Plant Name:  
Three Mile Island #1

Three Mile Island Nuclear Station Unit No. 1  
Docket Number 50-289

RESPONSES TO QUESTIONS RAISED IN ENCLOSURE 2

CONCERNING APPENDIX I

THREE MILE ISLAND UNITS 1 & 2

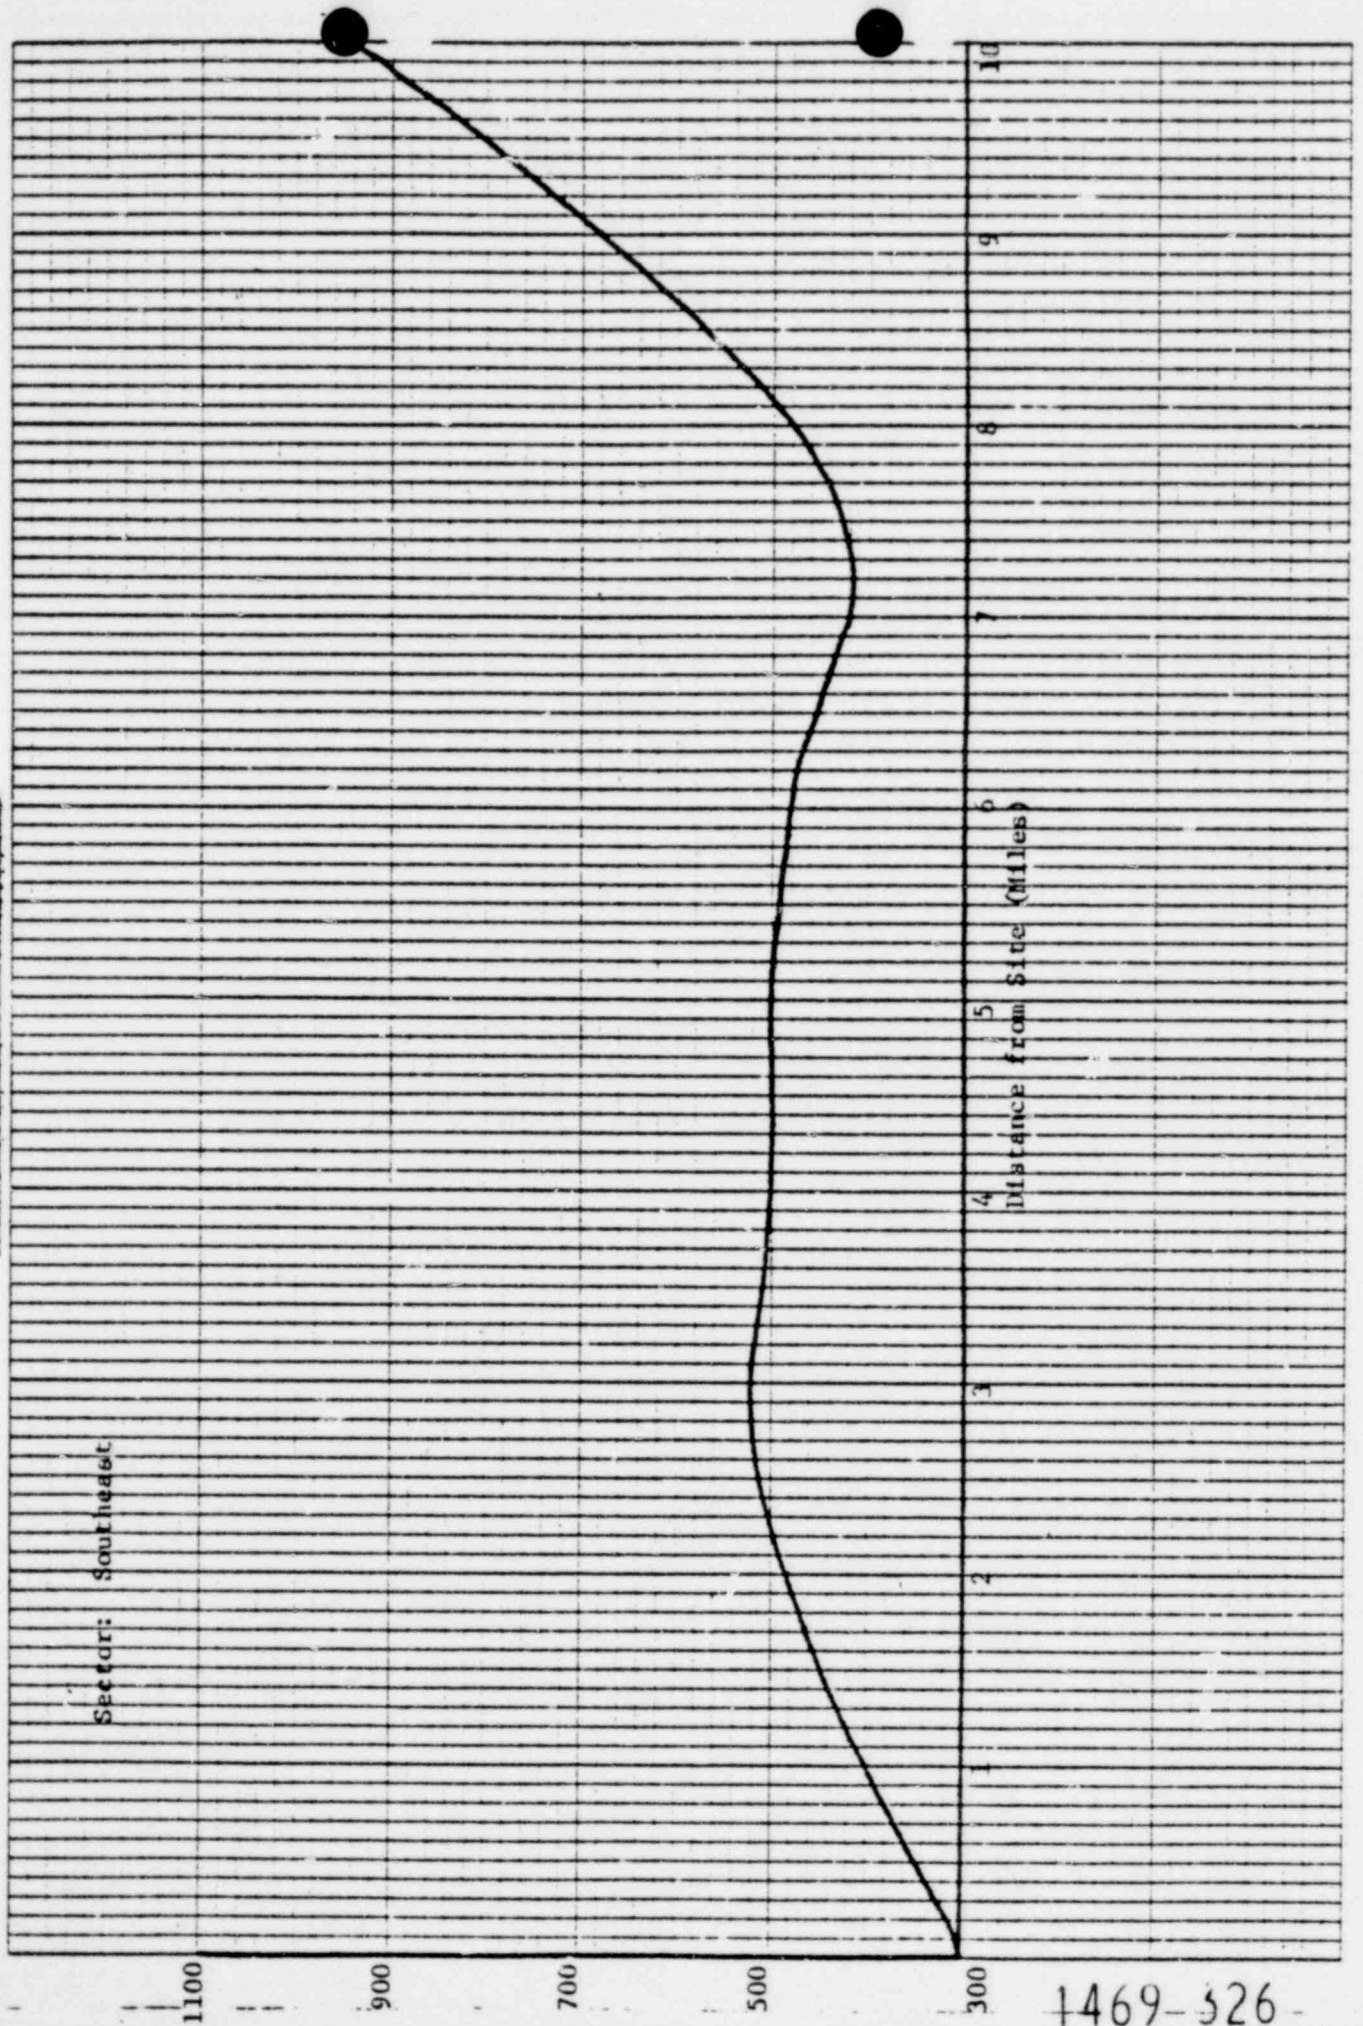
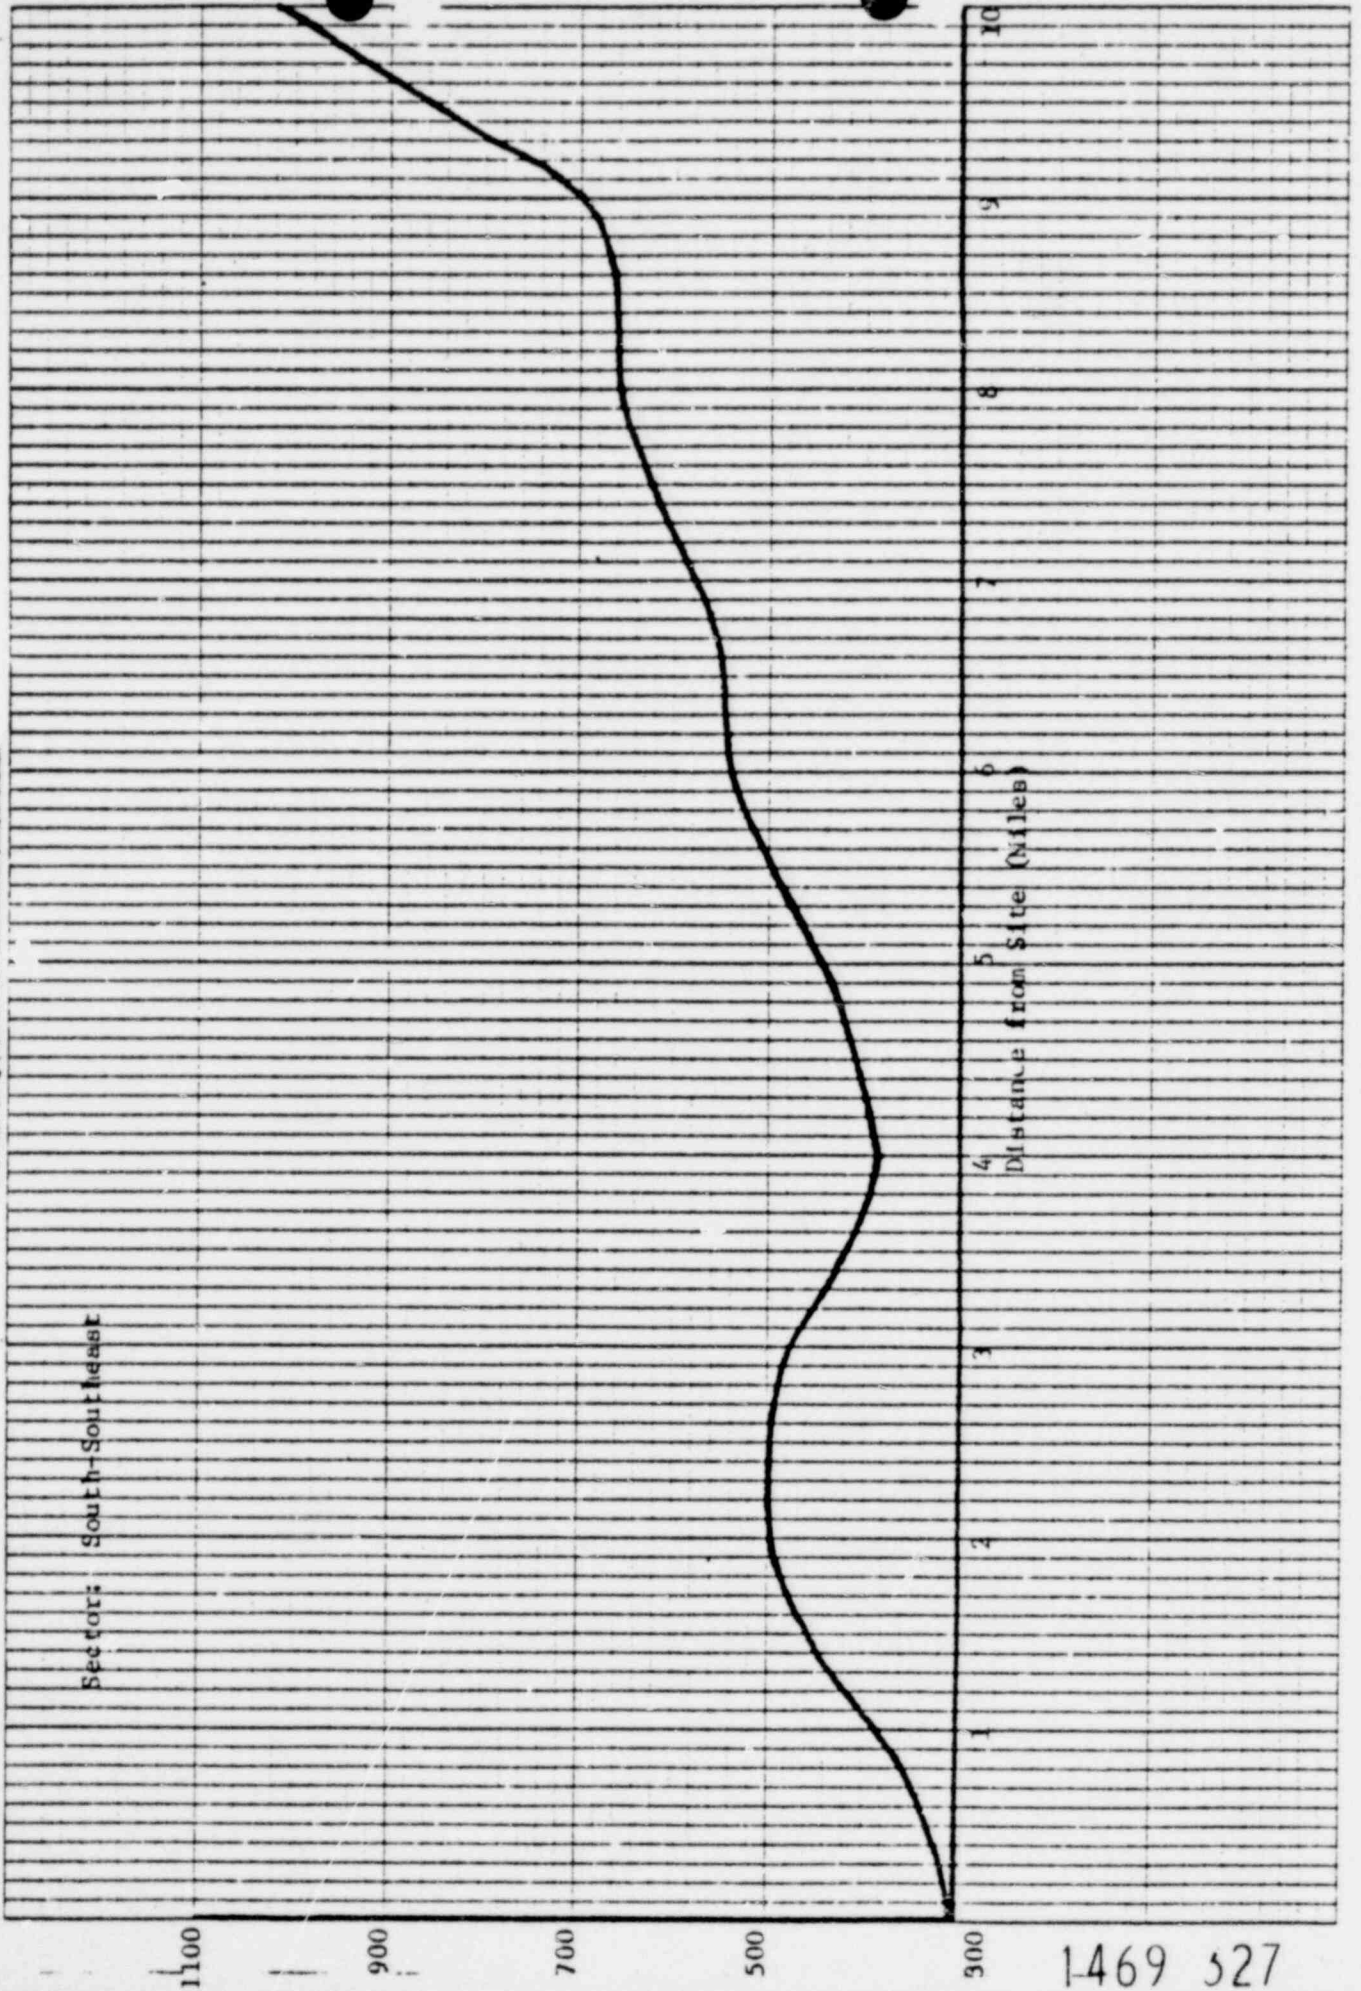
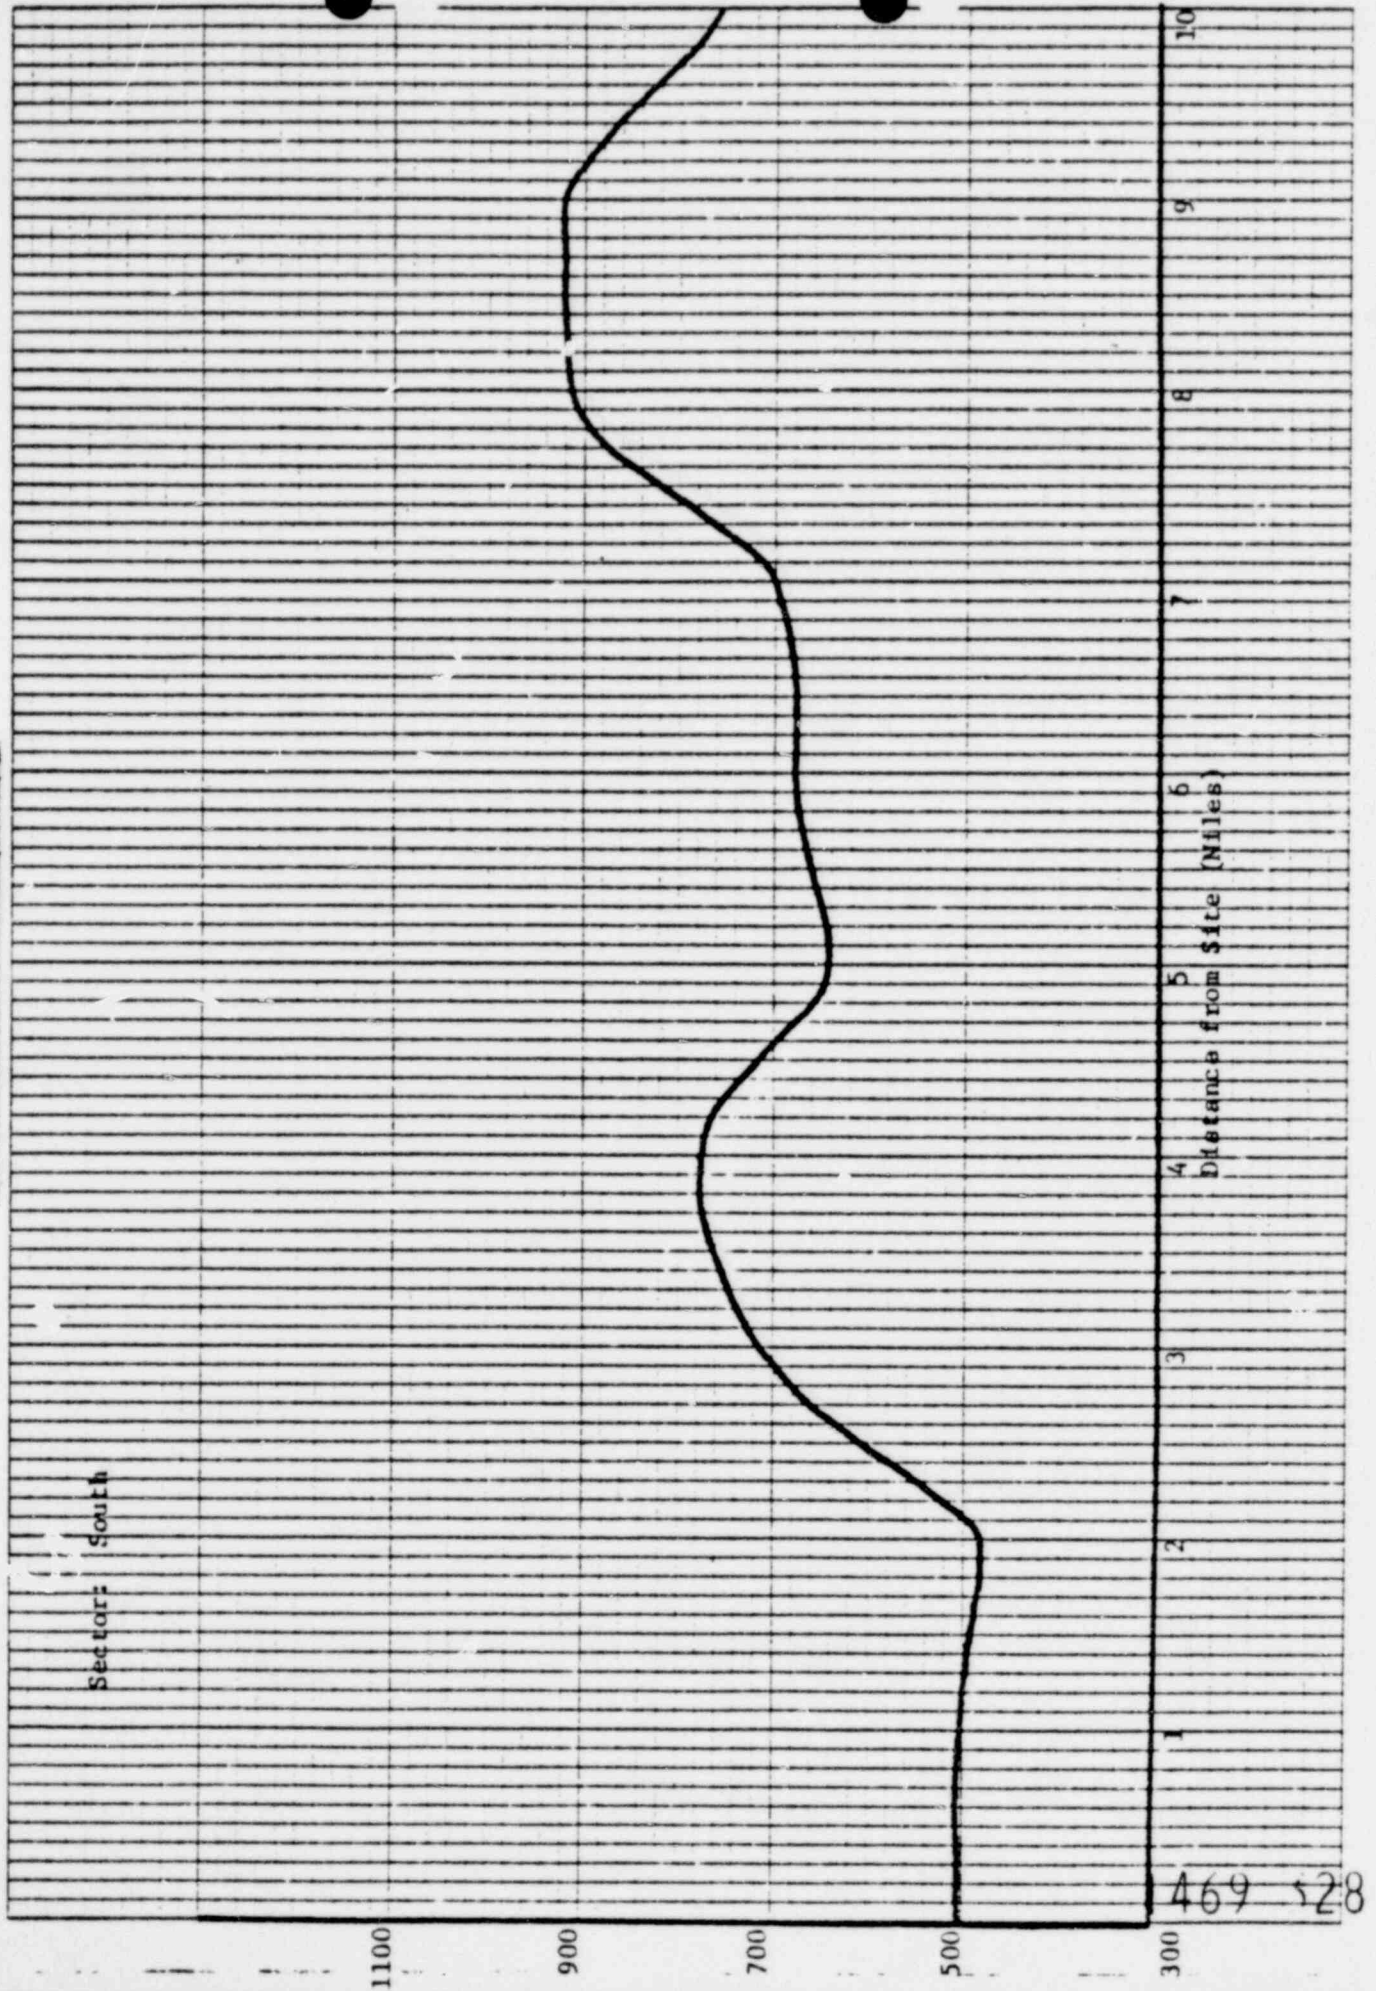
Provide a map showing the detailed topographical features (as modified by the plant) on a large scale, within a 10-mile radius of the plant and a plot of the maximum topographic elevation versus distance from the center of the plant in each of the sixteen 22-1/2 degree cardinal compass point sectors (centered on true north), radiating from the center of the plant, to a distance of 10 miles.

See attached Table 8-1 and Figures 8-1 through 8-16.
